FINAL DRAINAGE REPORT
FOR
VILLAGES AT STERLING RANCH

Include storm sewer design with HGL information

PCD Project No.
PSF-2439

INLET IN A SUMP OR SAG LOCATION

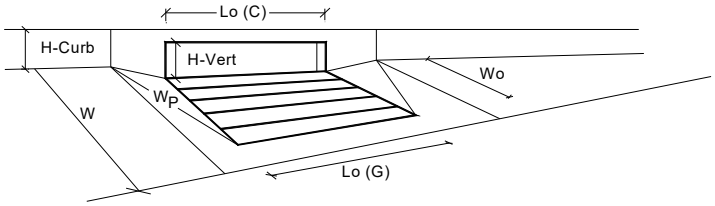
As only portion of design point was initially used, verify street capacity is adequate and any at-grade inlets are not needed prior to sump inlets.

CATCHMENT SHAPE PARAMETER FINDER

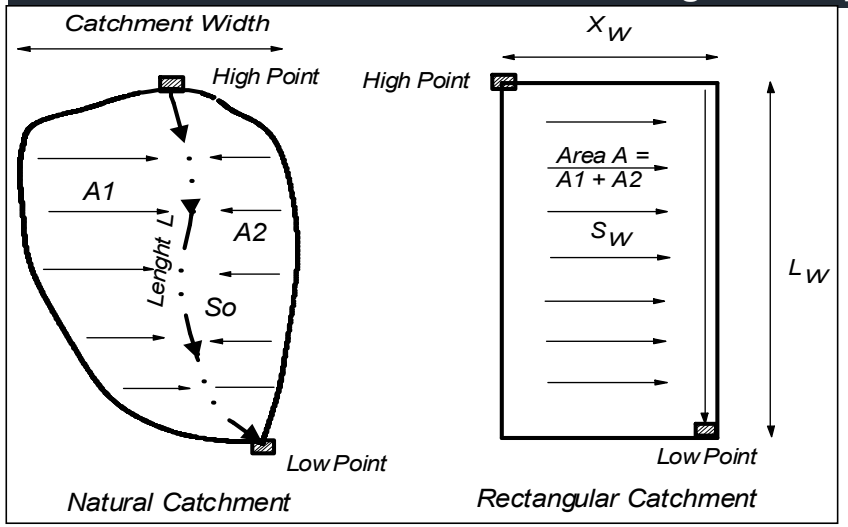
revise to not be percentages

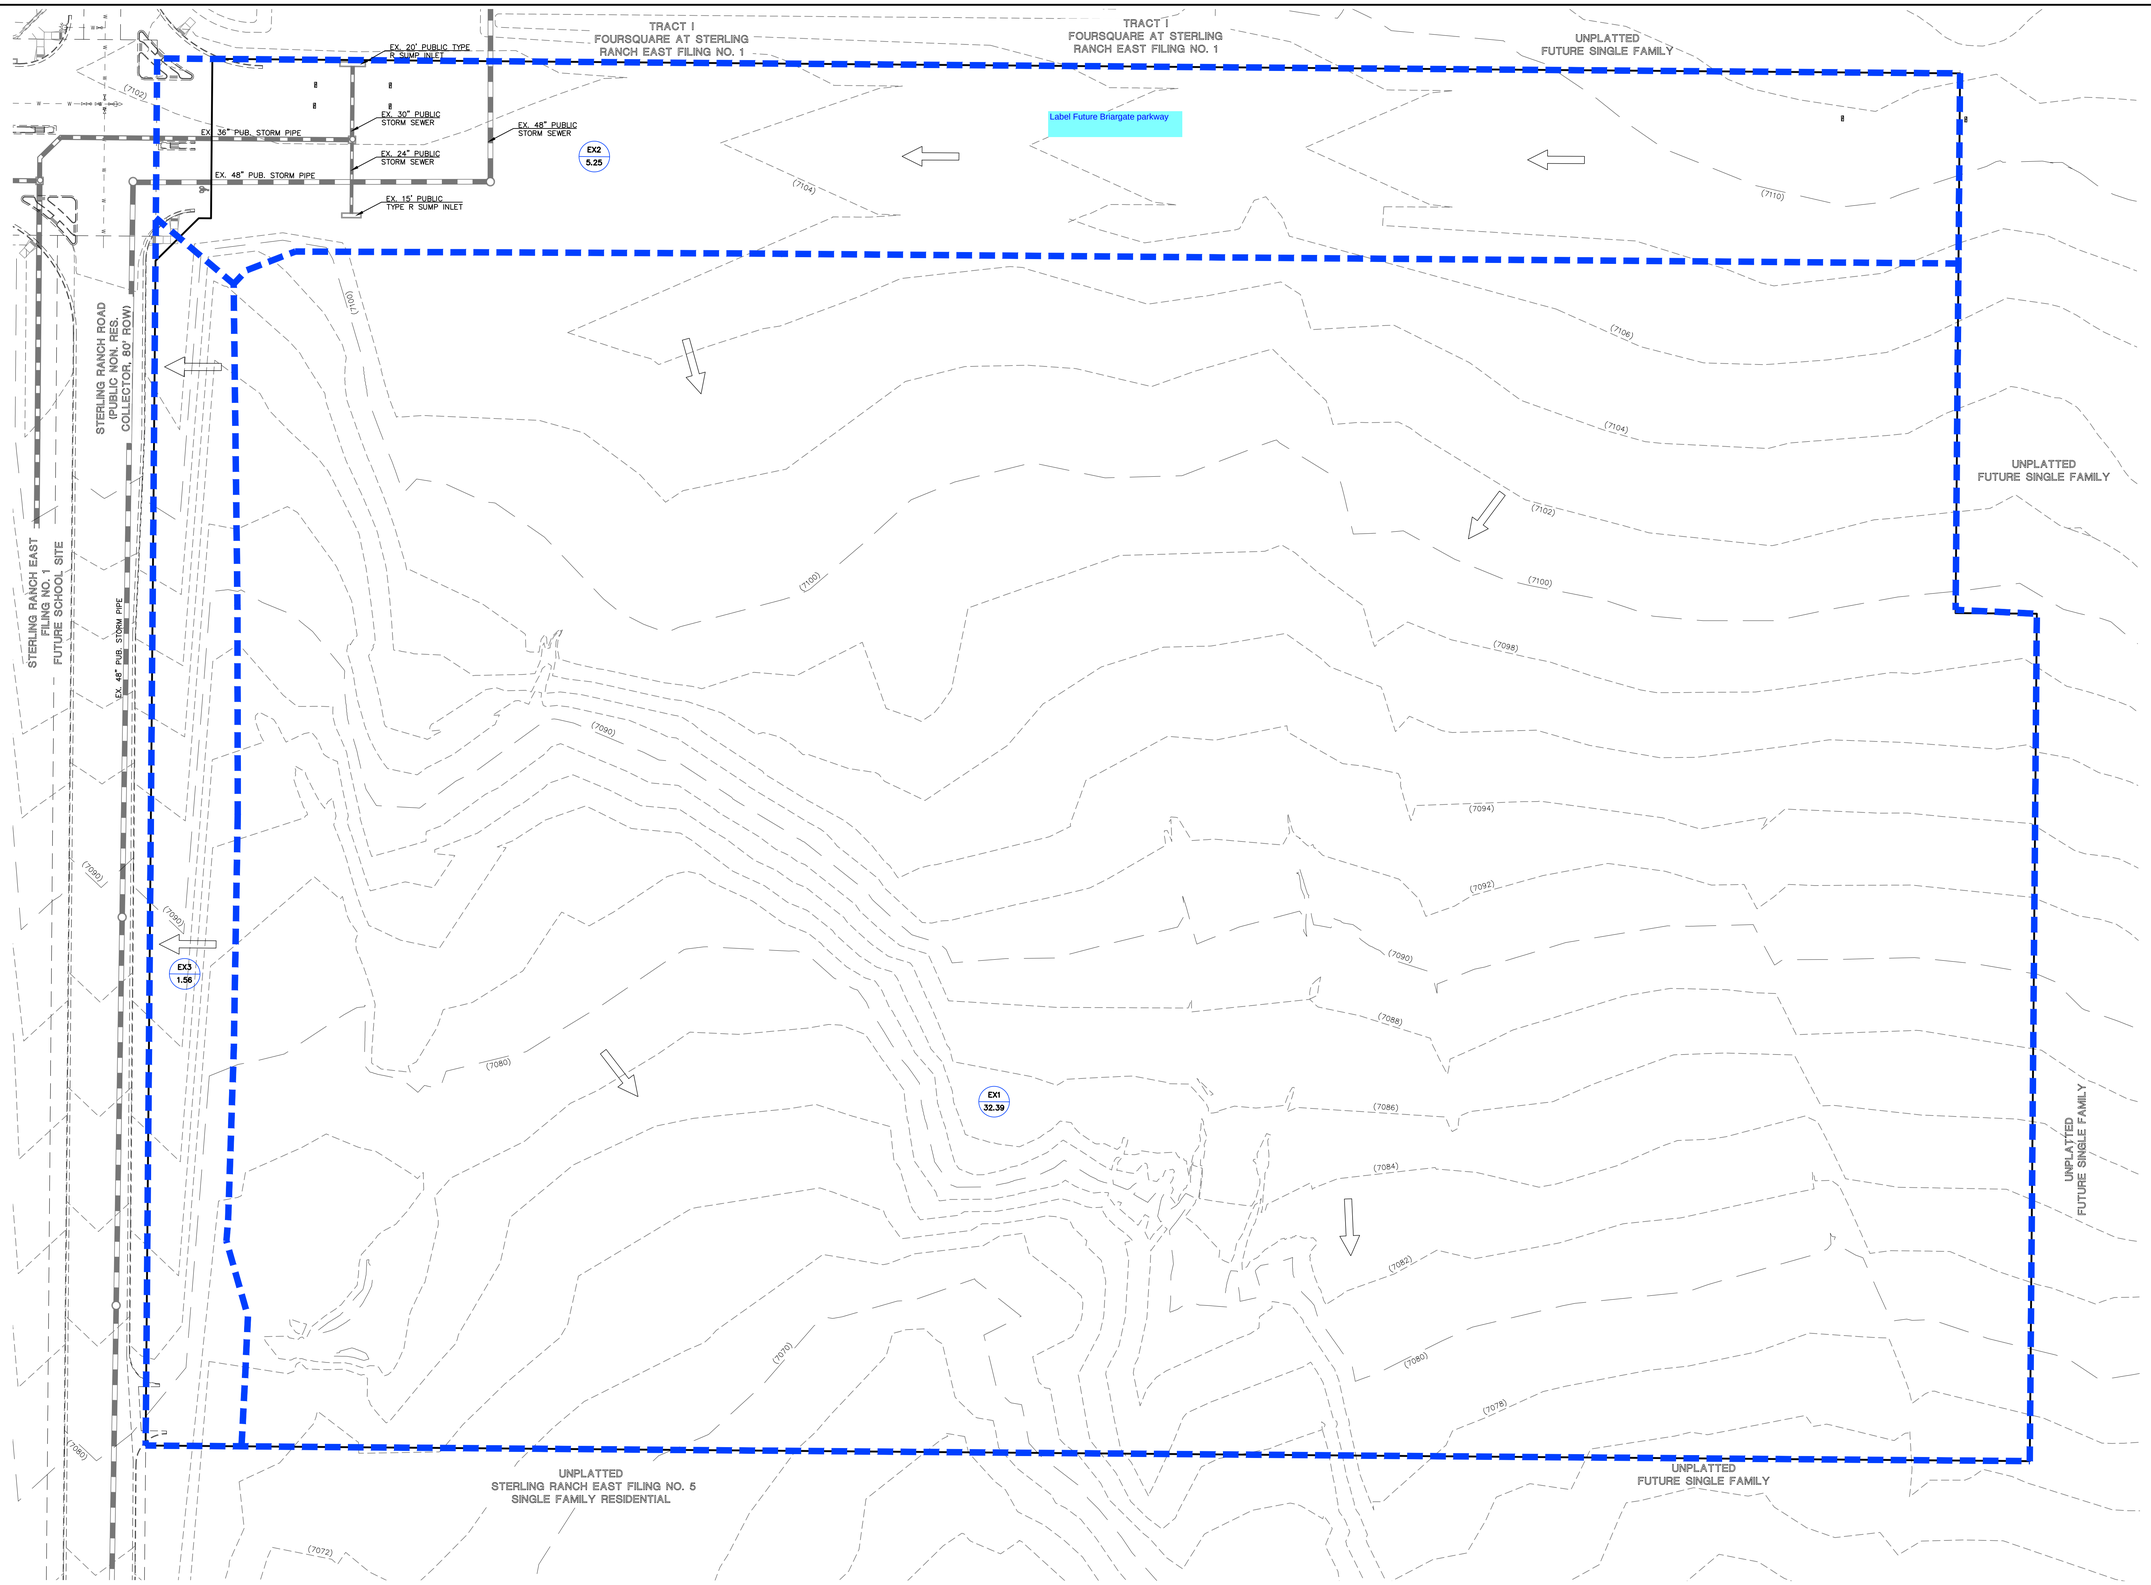
These 3 basins need to be broken into 6 basins (along north-south road). Flows can't just be split in half, as flows on each side of road will be different, based on different areas of contributing flow. Please provide own DP's for each inlet. (Per ECM Section 3.2.8.G, Design Points should be located each inlet.

Inlet spreadsheet shows a 30' inlet. Please verify size and update throughout report as needed.
